ADDENDUM #2

NORTH TRUCKEE DRAIN REALIGNMENT PHASE 1

BID #13/14-007 – PWP# WA-2014-011

This addendum is to notify all potential proposers of clarifications made to the Bid documents as stated below.

UTILITY NOTES :

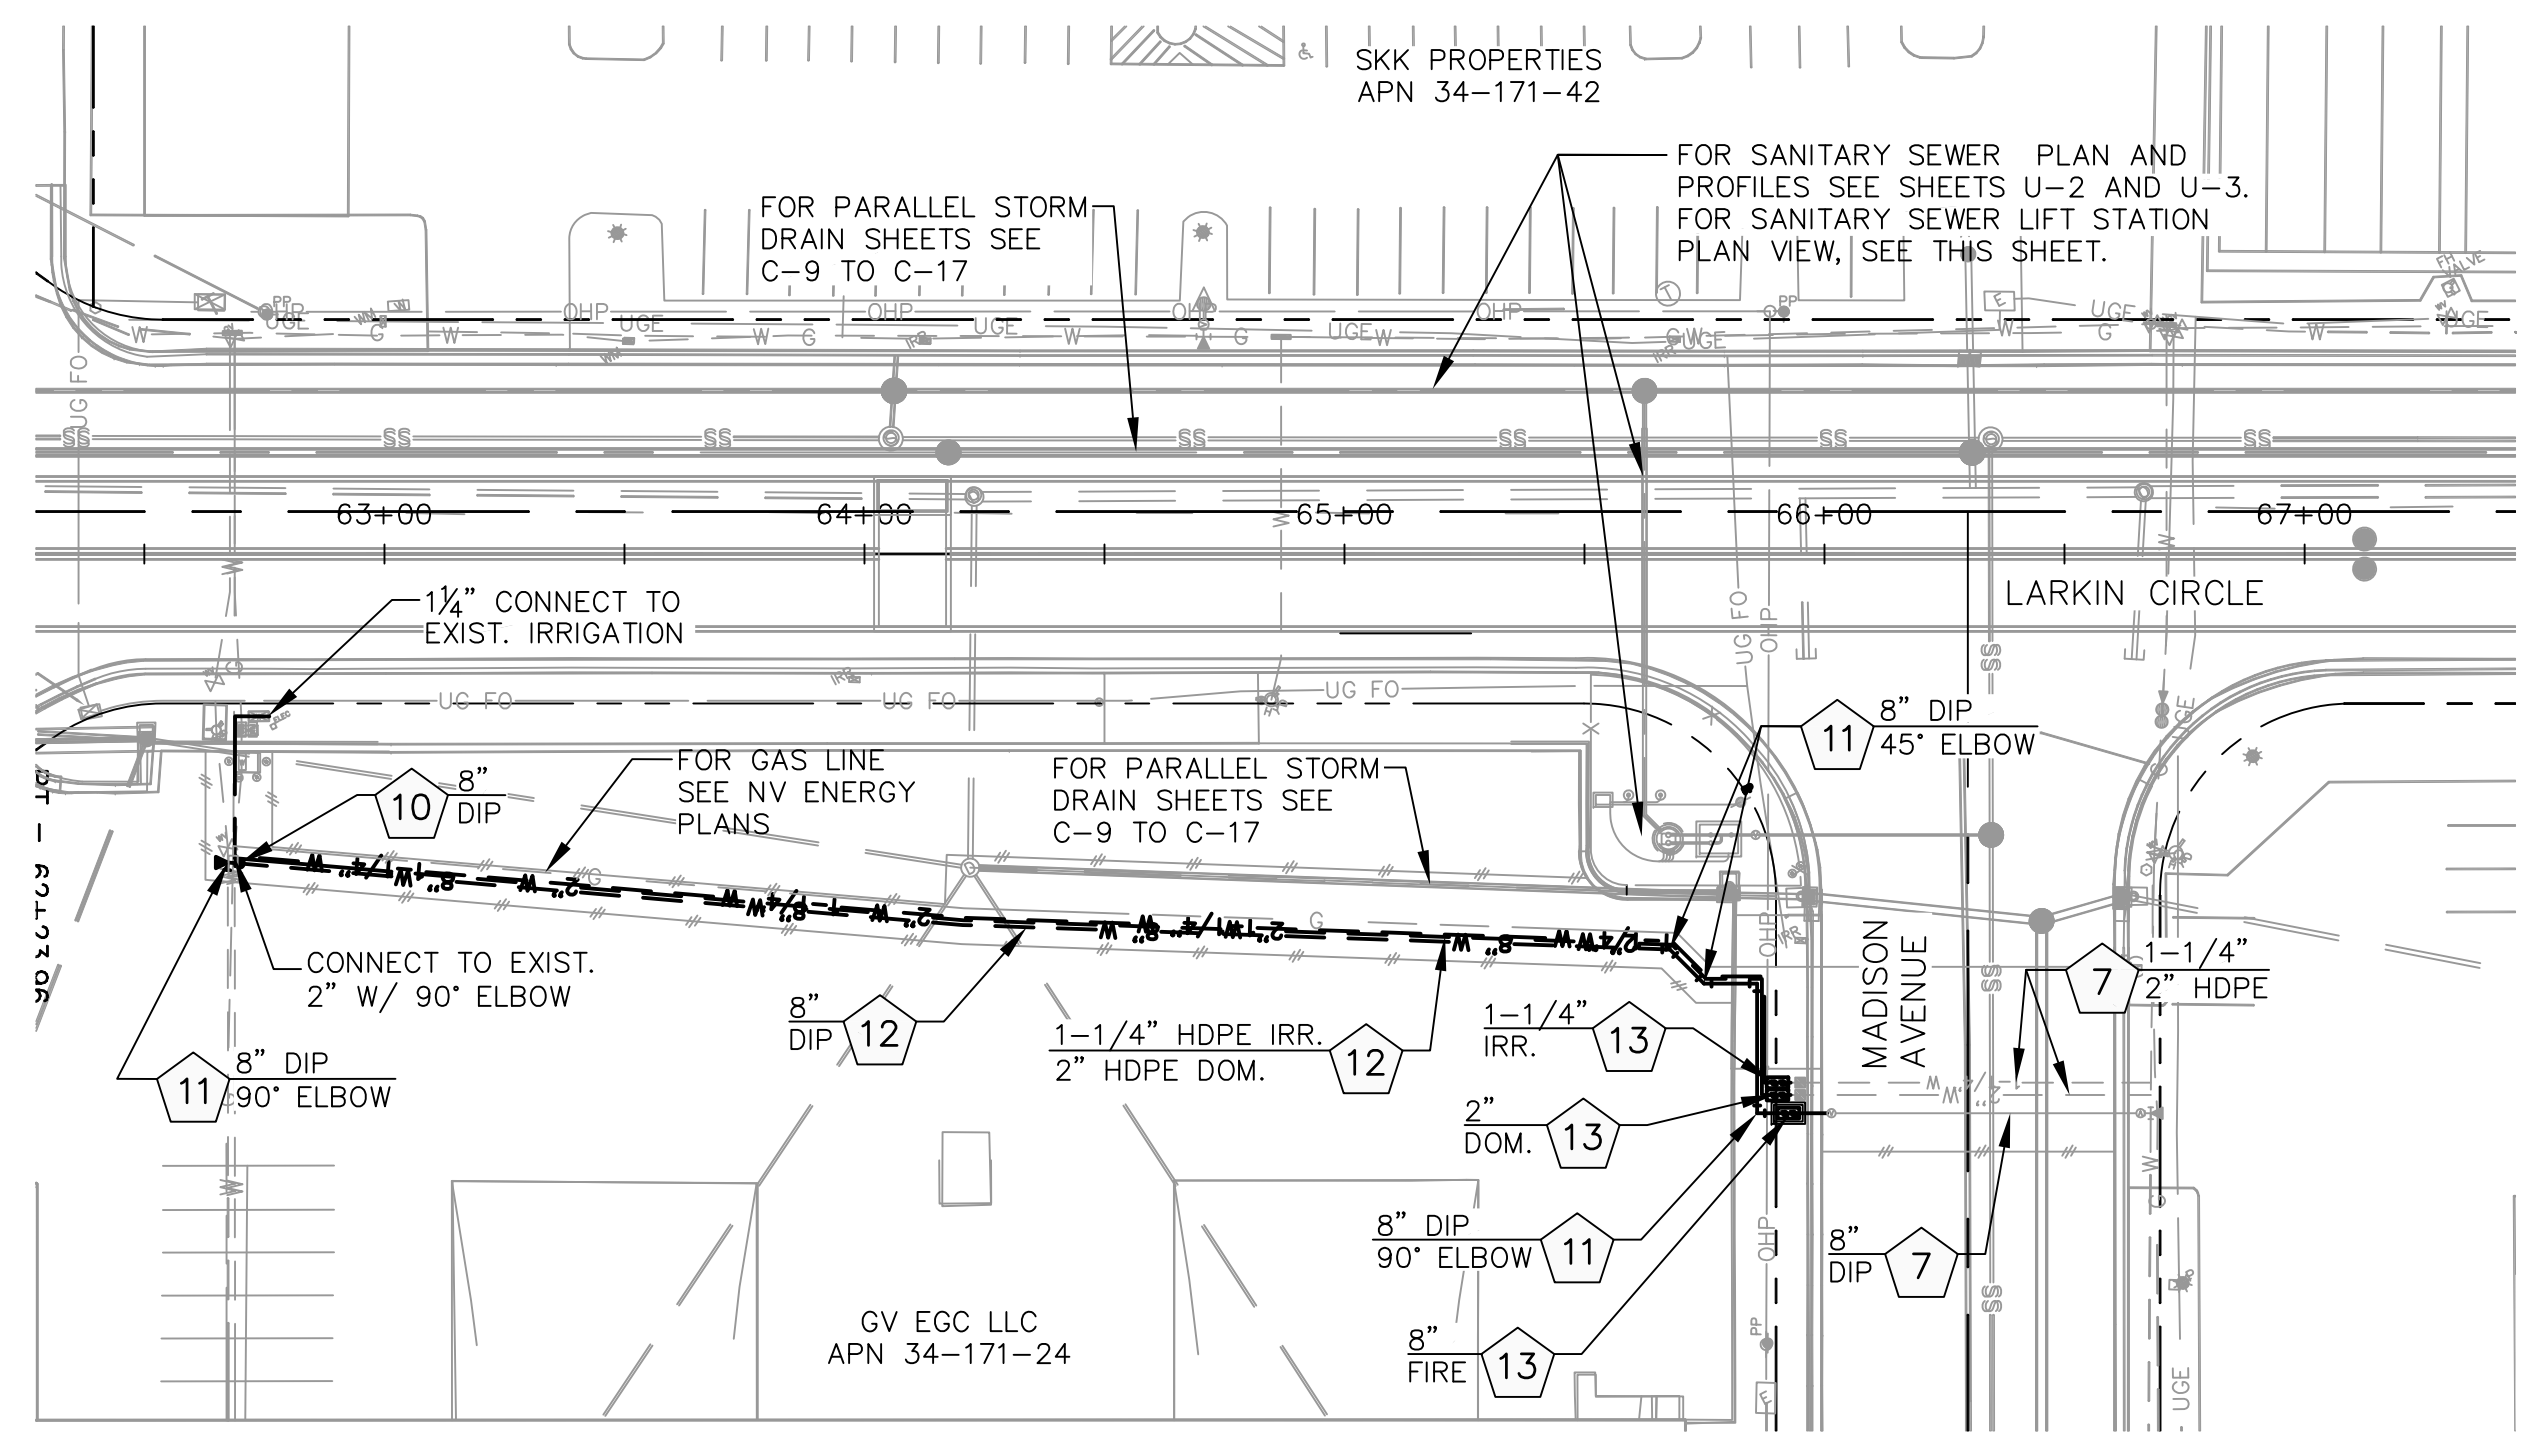
20. Sheet U-3 – In the upper middle and upper right details, sanitary sewer lift station enclosure fencing was highlighted.
21. Sheet U-4 – In the lower left detail, sanitary sewer lift station enclosure fencing was highlighted and notes were added.

EXHIBIT "A" APPLICANT INSTALLED CONDUIT ELECTRIC DESIGN	AUD#:	STL#:	GAS#: 3000412977	ELE#: 3000412977
SCALE: 1:100				
SHEET#: E.1

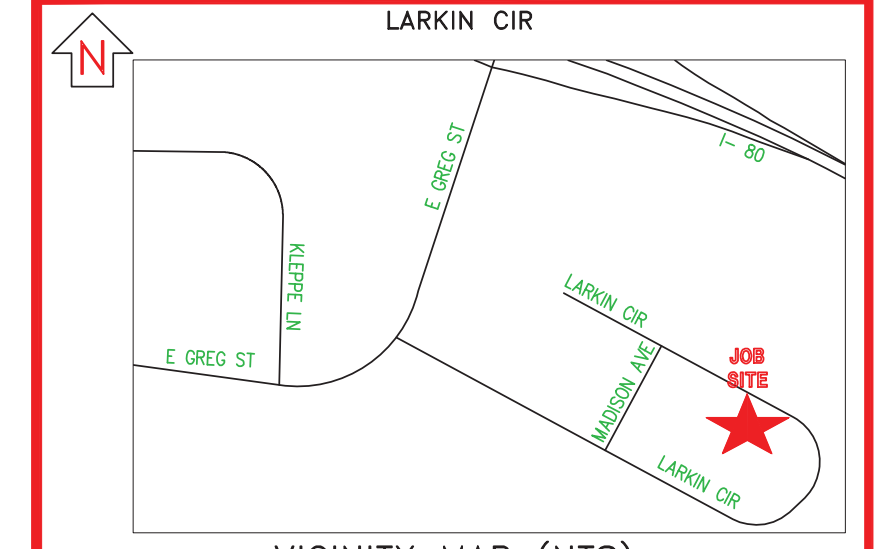
22. Sheet E.1 (NV Energy Electric Sheet 1 of 2) – Sheet was changed in its entirety.
